Re: Submittal of Response to Comments and Addendum to
Tyrone Stage 1 Abatement Plan Proposal, DP-1341 Condition 34

Addendum to the Tyrone Mine Facility Stage 1 Abatement Plan Proposal

**Response to June 2006 NMED Comments
Stage 1 Abatement Plan Proposal
DP-1341, Condition 34
Phelps Dodge Tyrone, Inc.**

Figure 2

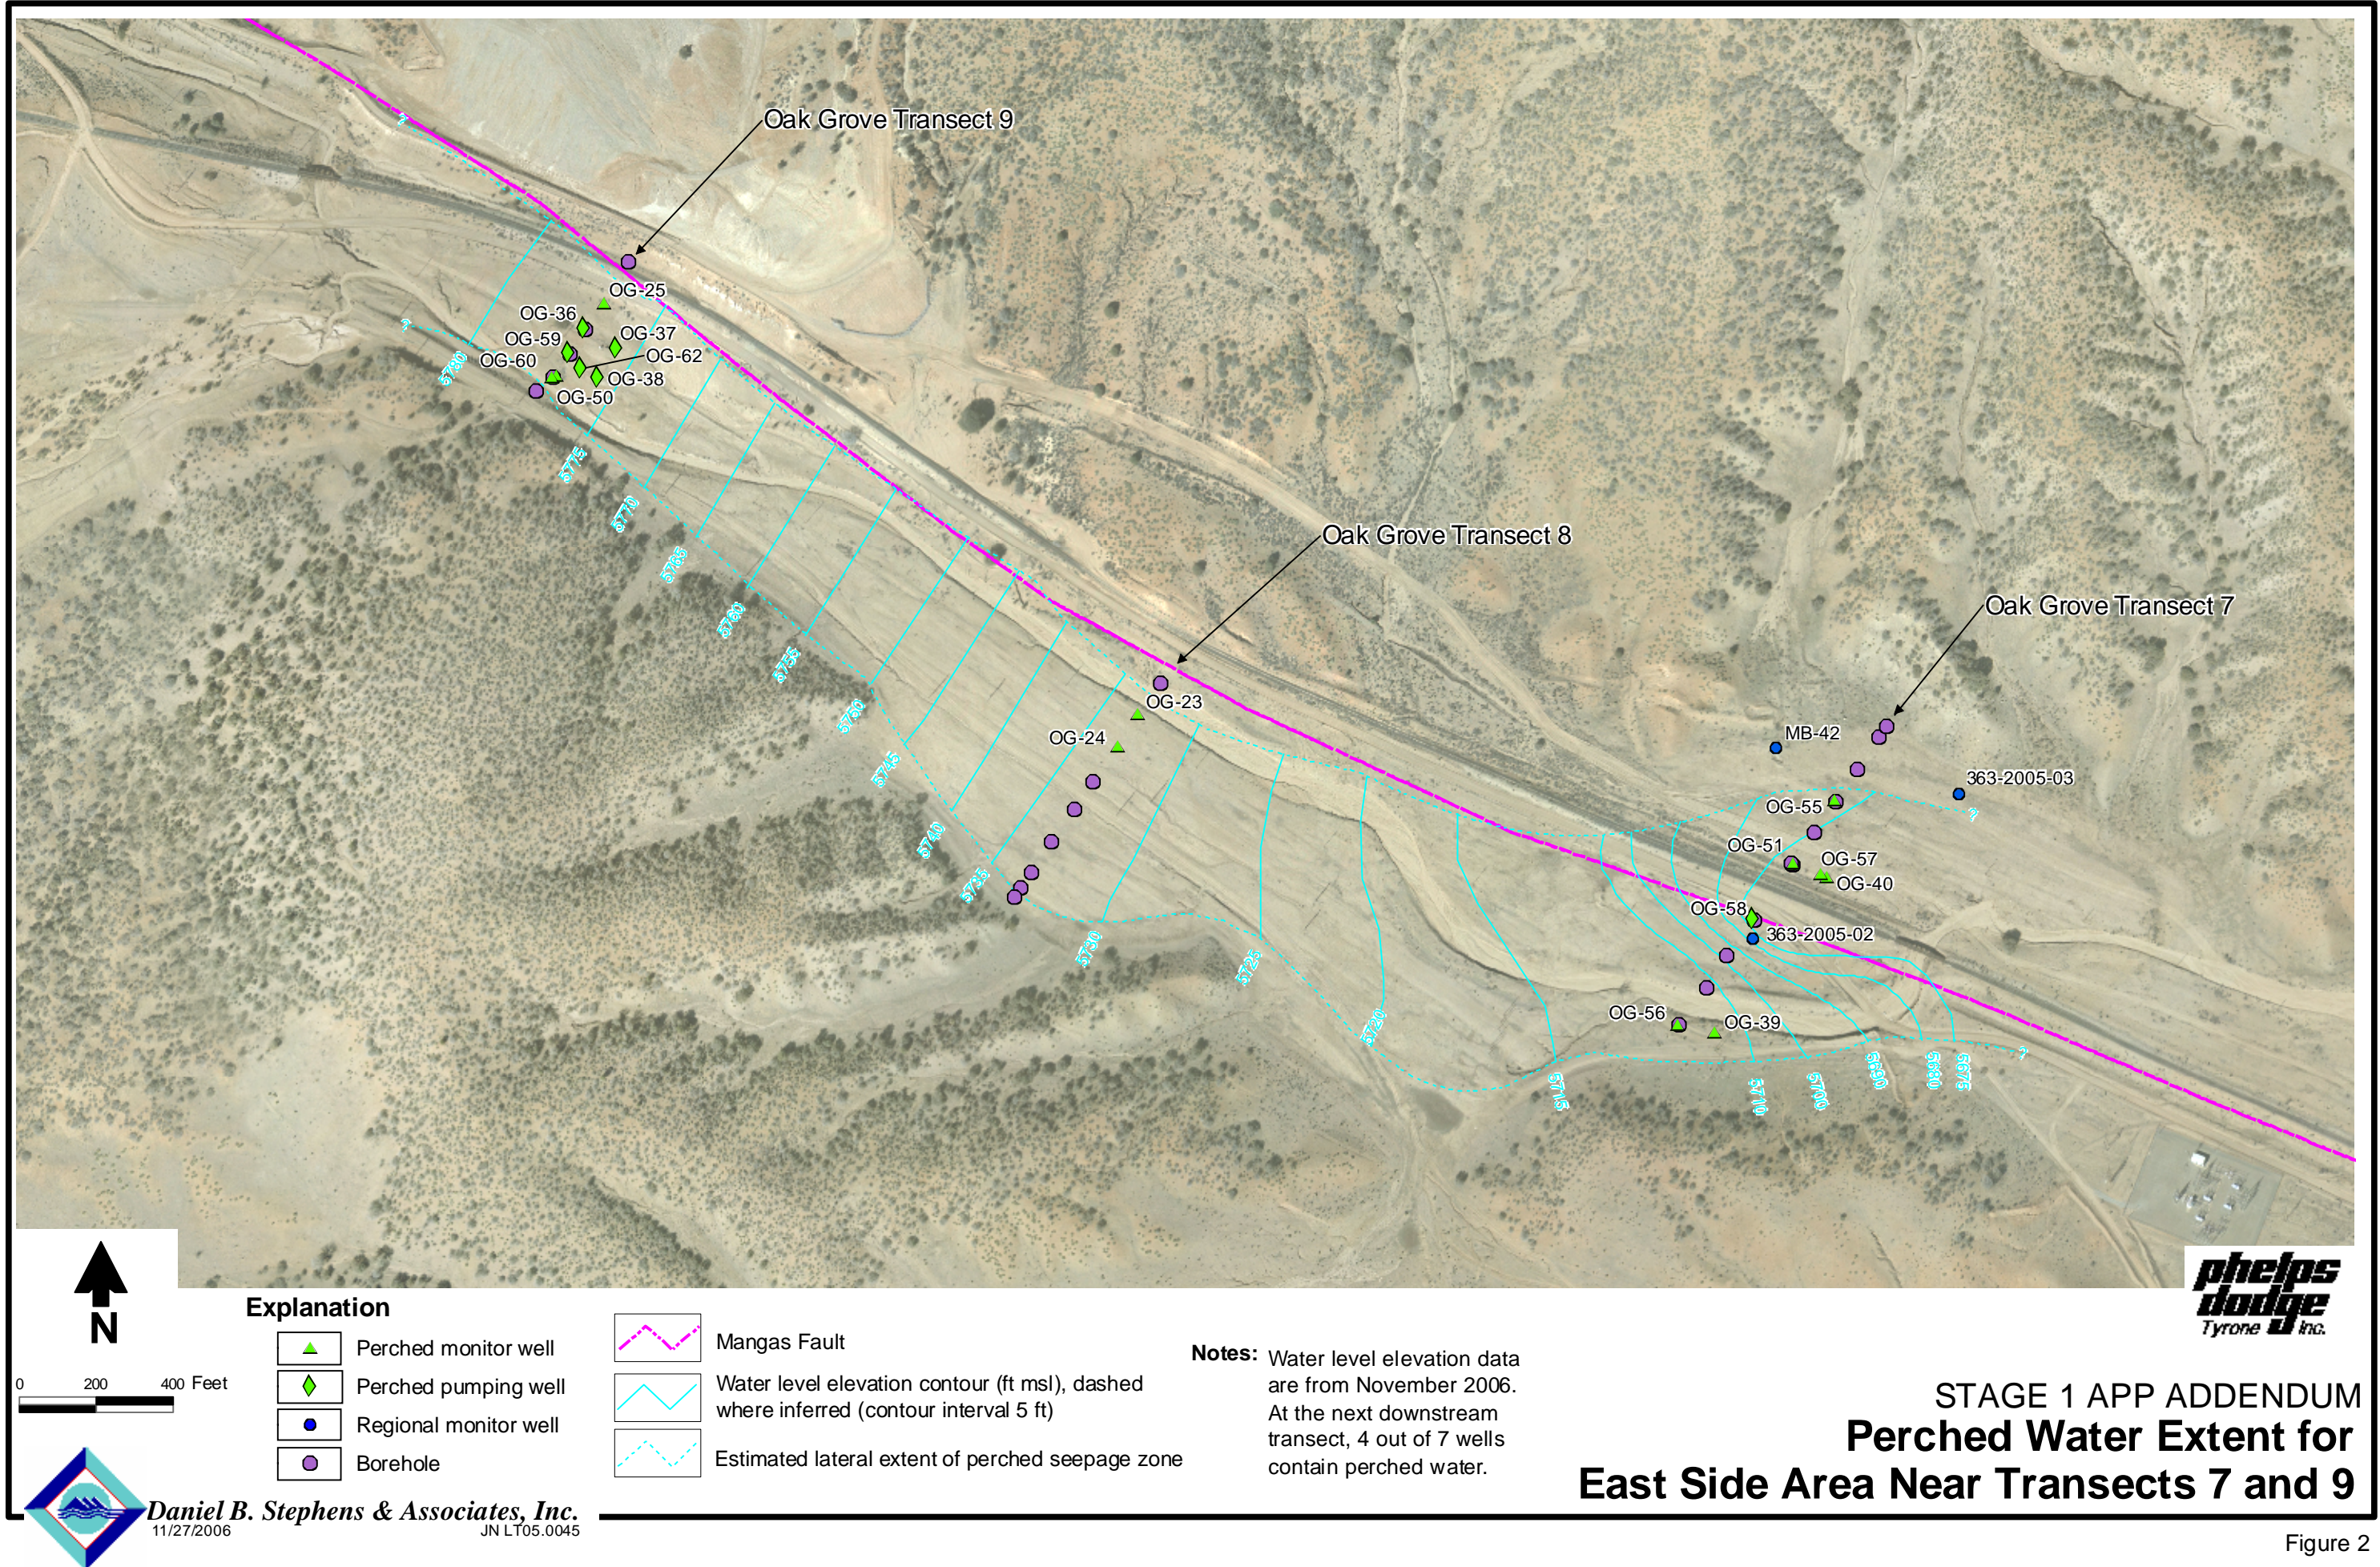
The second paragraph discusses the extent of contamination in the alluvial aquifer near Transect 9. PDTI must provide a more detailed map of this area showing all existing monitor wells, pumping wells and borings which define the lateral and vertical extent of contamination in this area. From the map provided in Figure 5, it does not appear that the lateral extent is well defined.

7. Section 3.2.1, Page 23. The second paragraph discusses the extent of contamination in the alluvial aquifer near Transect 9. PDTI must provide a more detailed map of this area showing all existing monitor wells, pumping wells and borings which define the lateral and vertical extent of contamination in this area. From the map provided in Figure 5, it does not appear that the lateral extent is well defined.

NMED (2006, Specific Comment No. 7) stated a concern that the lateral extent of groundwater contamination may not be well defined in this area. Although the comment refers to Oak Grove well Transect 9, it is PDTI's understanding from conversations with NMED that the concern is really focused on Transect 7 (Figure 2). Due to unsafe drilling conditions (overhead power lines in the area), an additional boring southwest of perched well OG-56, at the southwest end of Transect 7, was not completed (DBS&A, 1997). The lateral extent of perched water, however, can be inferred from the upstream Transect 8 (along wells OG-23 and OG-24), as shown in Figure 7 of the February 1997 No. 1A stockpile seepage investigation progress report (DBS&A, 1997). The estimated lateral extent of perched water in Figure 2 is consistent with the lateral extent determined at Transect 8 through drilling. PDTI believes that the lateral (cross-gradient) extent of contaminated water in this area is adequately defined based on the available transects of wells and borings, as illustrated in Figures 2 and 3.

Note in Figure 2 that the delineated lateral extent of perched water in the downgradient direction (i.e., along Oak Grove Wash) is not closed, as it has been shown in some previous East Side perched zone maps submitted by PDTI. This is because water levels measured during November 2006 indicate that saturated conditions occur in the alluvium at four of the seven monitor wells in the next downgradient well transect (Transect 6, not shown on Figure 2). PDTI is currently in the process of acquiring and installing continuous water level recorders in two perched zone monitor wells in Oak Grove Wash to better monitor transient changes in perched zone water levels. One recorder will be installed in Oak Grove Transect 3, located about 2,400 feet southeast of Transect 6, and the other in Transect 1, located just upstream of the confluence of Oak Grove Wash and Brick Kiln Gulch. This activity was proposed under Section 3.4.4. of the Stage 1 APP. PDTI is also in the process of considering additional measures that can be implemented to capture and reduce the extent of contaminated alluvial water in Lower Oak Grove Wash.

Figure 6

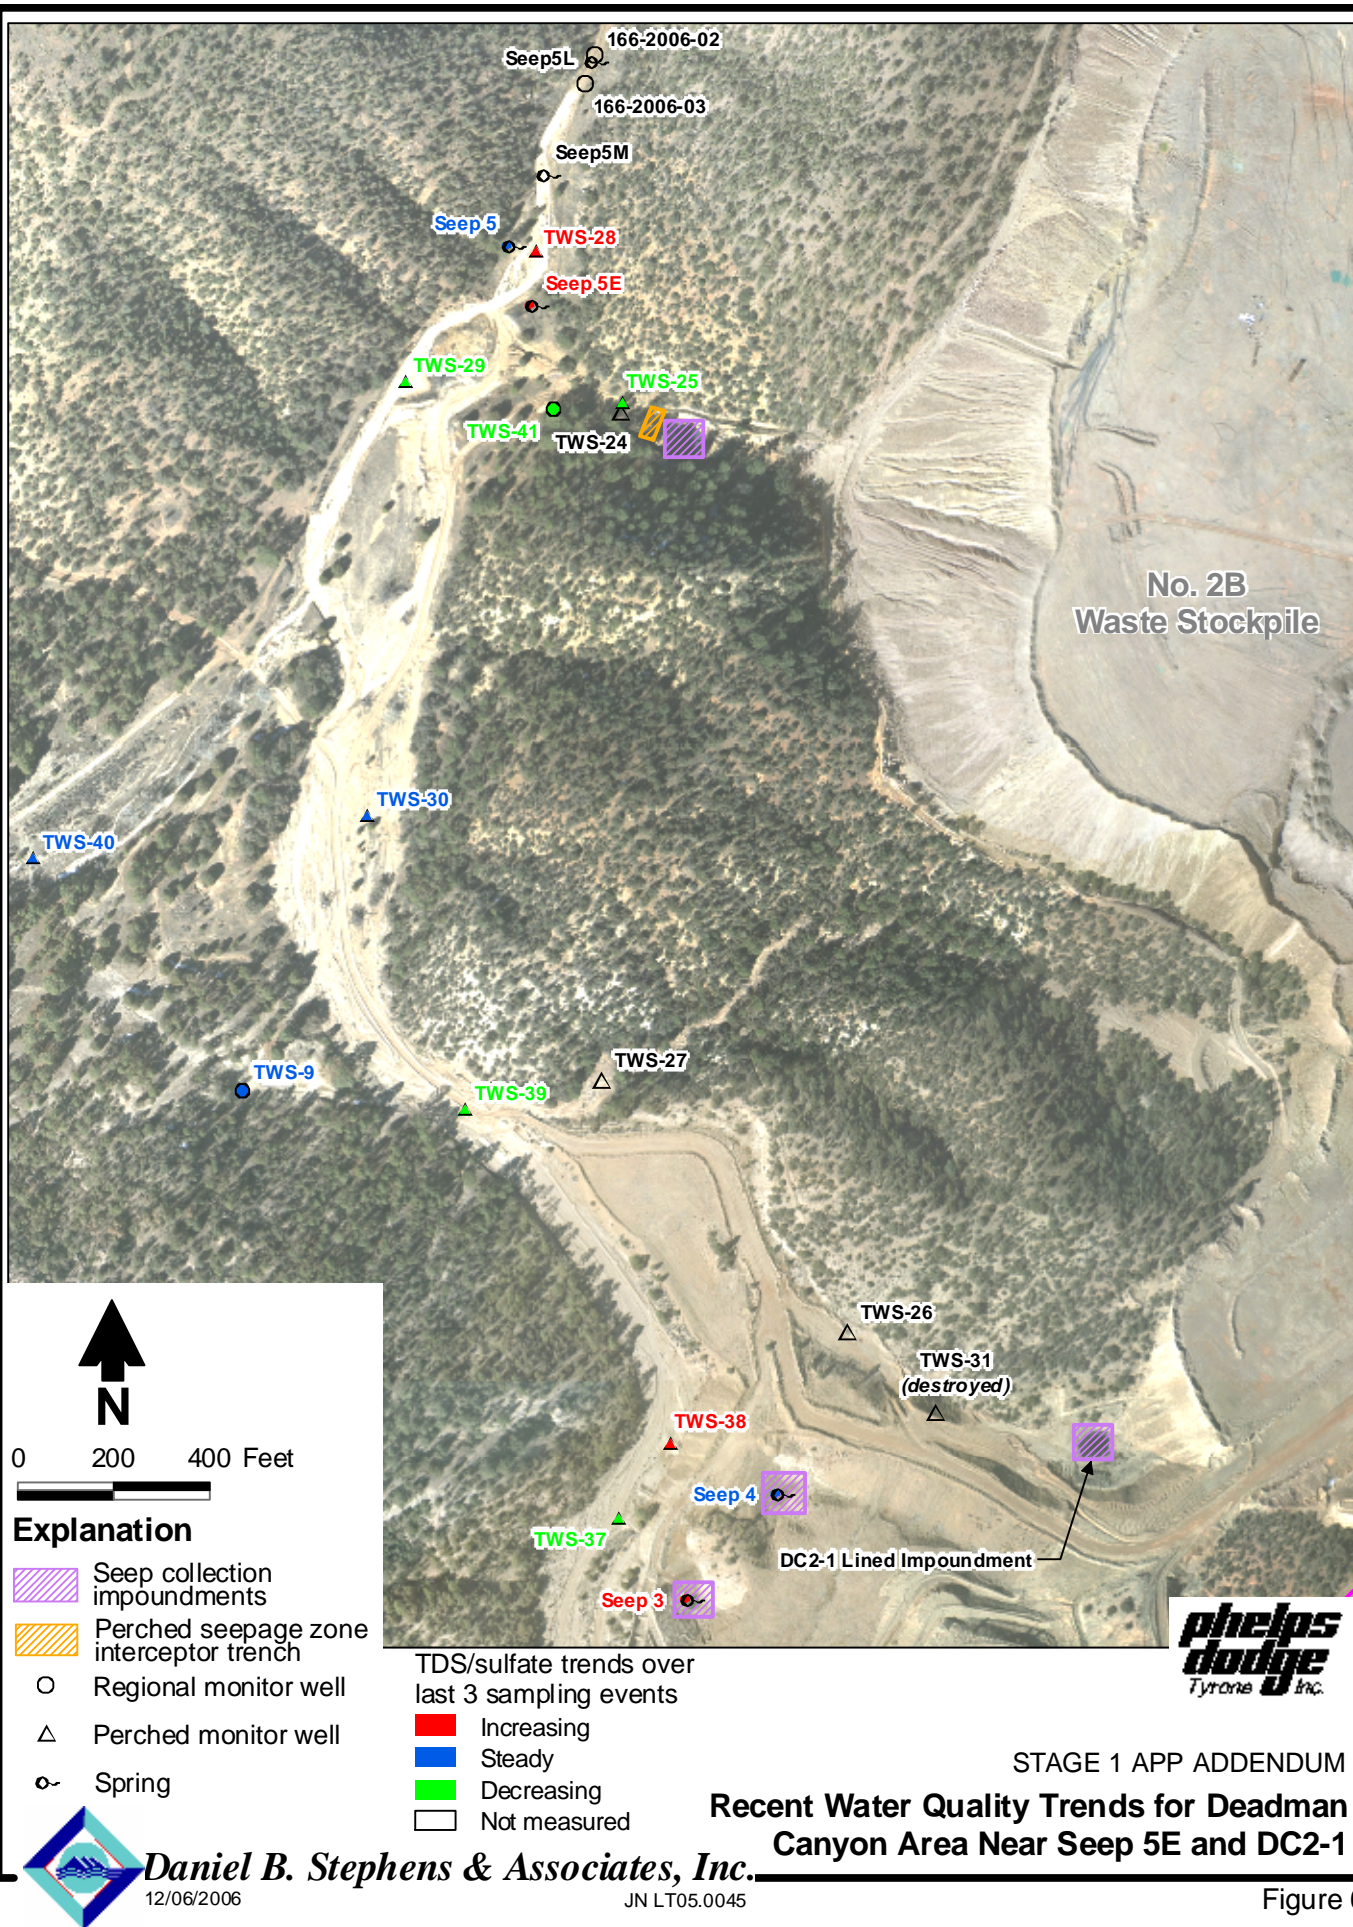
The third paragraph states that monitoring well TWS-25 went dry back in 2001. PDTI must provide more discussion on the extent of contamination in the area surrounding Seep 5E. Given the poor water quality at Seep 5E and rising TDS and sulfate concentrations in wells TWS28 and TWS-29 (Page 28), at a minimum well TWS-25 should be replaced. A detailed map of this area showing the locations of all existing monitoring wells and seepage collection systems, and the extent of ground water contamination must be provided. Based on this information, more wells may be required.

8. Section 3.2.1, Page 23. The third paragraph states that monitoring well TWS-25 went dry back in 2001. PDTI must provide more discussion on the extent of contamination in the area surrounding Seep 5E. Given the poor water quality at Seep 5E and rising TDS and sulfate concentrations in wells TWS28 and TWS-29 (Page 28), at a minimum well TWS-25 should be replaced. A detailed map of this area showing the locations of all existing monitoring wells and seepage collection systems, and the extent of ground water contamination must be provided. Based on this information, more wells may be required.

locations. Note that the well and seep locations are provided in Figure 6. Perched zone well TWS-29 is in Deadman Canyon upgradient of Seep 5E, while perched zone well TWS-28 is in Deadman Canyon downgradient of Seep 5E. TWS-41 is a regional aquifer monitoring well adjacent to the Deadman canyon tributary that contains Seep 5E.

As Figure 7 indicates, although the water quality in Seep 5E has improved significantly since 2001, seep water still exceeds groundwater standards. For example, in September 2006 the seep exceeded standards for TDS (1,590 milligrams per liter [mg/L]), sulfate (983 mg/L), cadmium (0.0595 mg/L), cobalt (0.387 mg/L), copper (138 mg/L), fluoride (6.18 mg/L), and manganese (12.3 mg/L). Seep 5E was dry when attempts were made to sample the seep in September 2005, March 2006, and June 2006.

Additional discussion and a map of the Seep 5E area is provided in Section 2.2.1 of the Addendum to the Stage 1 APP. Additional groundwater quality investigation in Deadman Canyon is proposed in the CPT work plan.

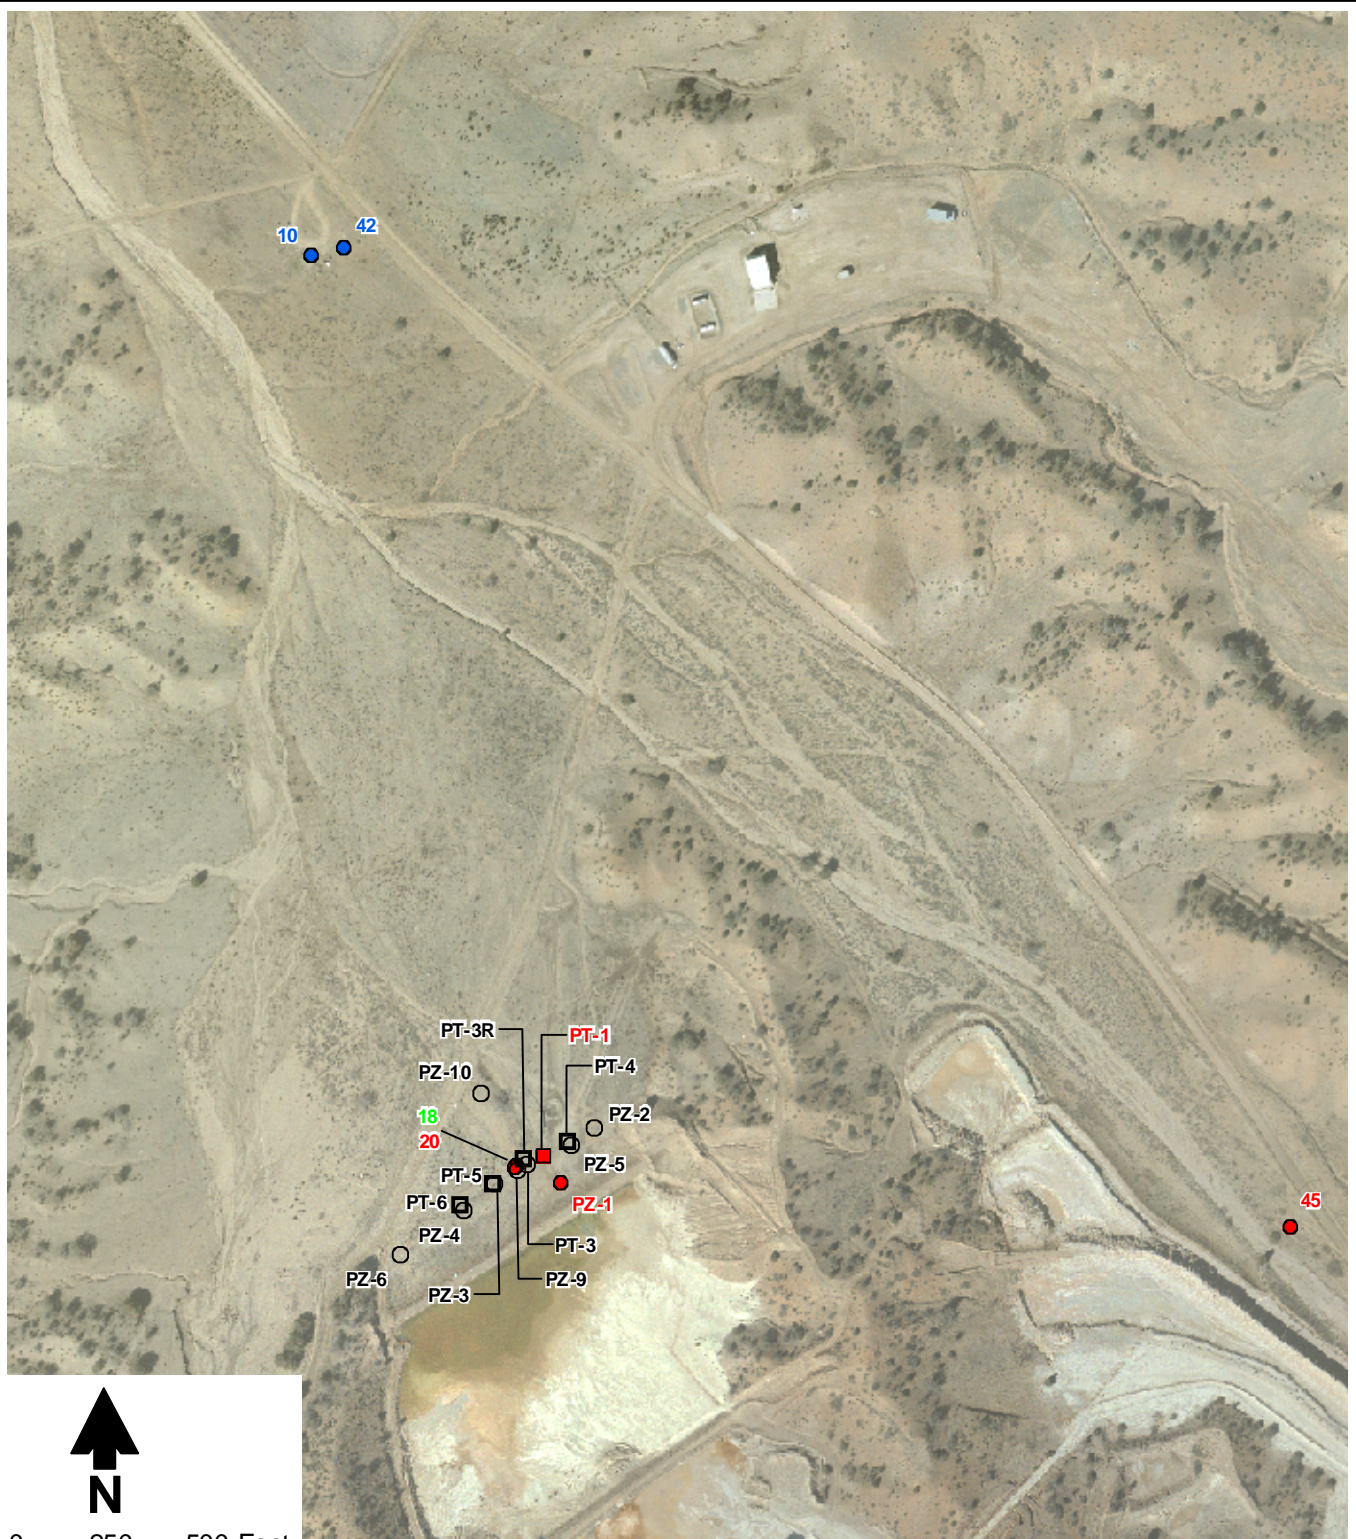
The regional groundwater quality maps in the APP must be updated to show more recent data as well as data from the new monitoring wells installed at the Tyrone Mine. The maps presented are general in nature and more detailed maps must be provided for areas affected by contamination in the alluvial as well as the regional aquifer. Specifically, the areas surrounding Seep 5E (Comment 8), Seep DC2-1 (Comment 9), the northern perimeter of the No. 3 Stockpile (Comment 18), and the 1X Collection System. Different colors or symbols should be used to indicate monitoring wells that have increasing concentrations of TDS/sulfate over the last three sampling events.

10. Figures 7a, 7b and 7c, Pages 29-31. The regional groundwater quality maps in the APP must be updated to show more recent data as well as data from the new monitoring wells installed at the Tyrone Mine. The maps presented are general in nature and more detailed maps must be provided for areas affected by contamination in the alluvial as well as the regional aquifer. Specifically, the areas surrounding Seep 5E (Comment 8), Seep DC2-1 (Comment 9), the northern perimeter of the No. 3 Stockpile (Comment 18), and the 1X Collection System. Different colors or symbols should be used to indicate monitoring wells that have increasing concentrations of TDS/sulfate over the last three sampling events.

Figure 11 shows recent regional groundwater quality in the No. 3A stockpile area and is an updated version of Figure 7b presented in the Stage 1 APP (DBS&A, 2004). Note that only wells with water quality analysis within the 2005 to 2006 timeframe are illustrated in Figure 11. Figure 12 is a map of the No. 3A stockpile toe showing all existing regional wells (monitor and pumping) and recent water quality trends of the past three sampling events for sulfate and TDS where data is available. P-203 in Canyon 11, P-196 in Canyon 7, and P-6B in Canyon 1 show increasing sulfate and TDS trends, while the remaining wells with recent water quality data along the toe have either steady or decreasing sulfate and TDS concentrations.
